# Nº 166 Service Bulletin

**SUBJ:** Grand Prix / NASCAR®  
Trough Up-Kicker Failure

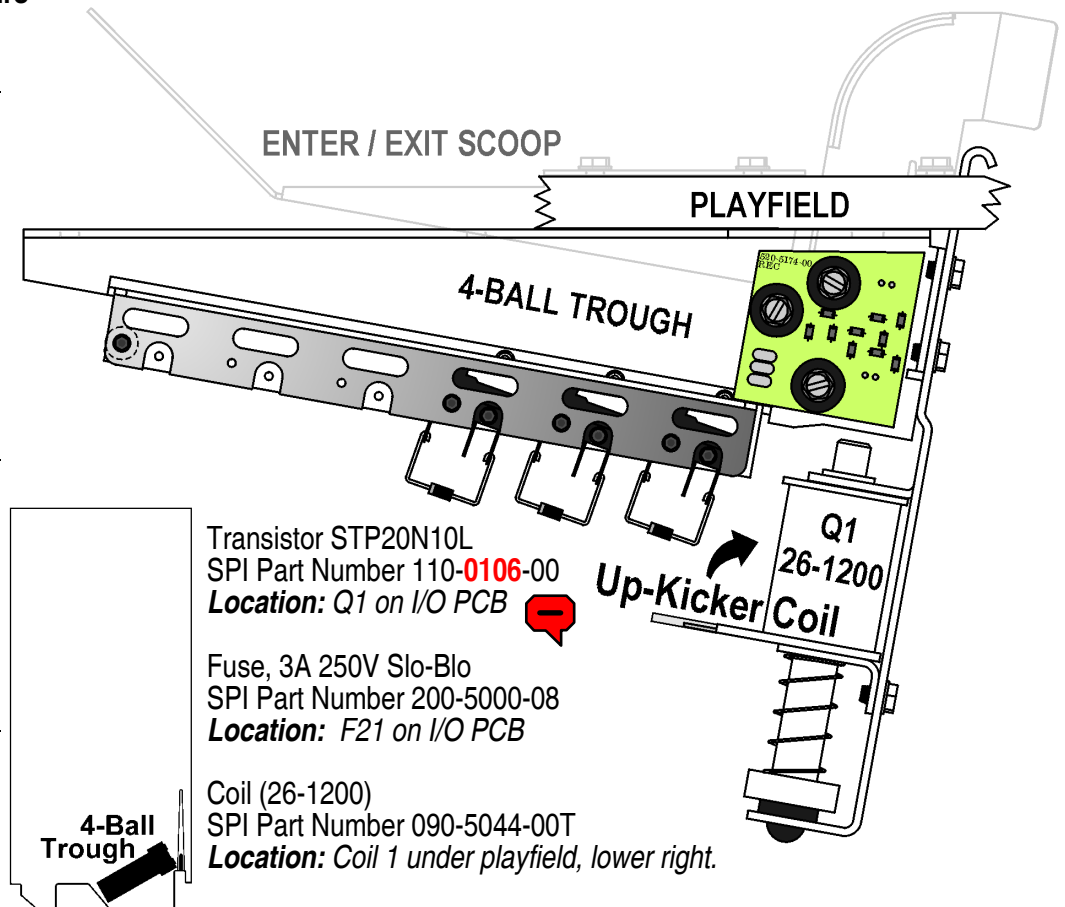
- Game will not start.
- 50VDC coils are inoperable.
- I/O Power Driver PCB F21 3A 250V SLO-BLO Fuse is blown.
- Trough Up-Kicker (*Coil #1*) is overheating (*paper wrap is browned*).
- **Q1** Transistor STP20N10L (*on I/O PCB*) is shorted.

The Game Software Version **4.20** or lower (*U210 on the CPU/Sound Board II*) has a problem in which it may repetitively fire the Trough Up-Kicker Coil when serving the ball up to the *Shooter Lane*.

**Ensure your Game Code** on your CPU/Sound Board in location U210 is **v4.50+** and replace all faulty components.
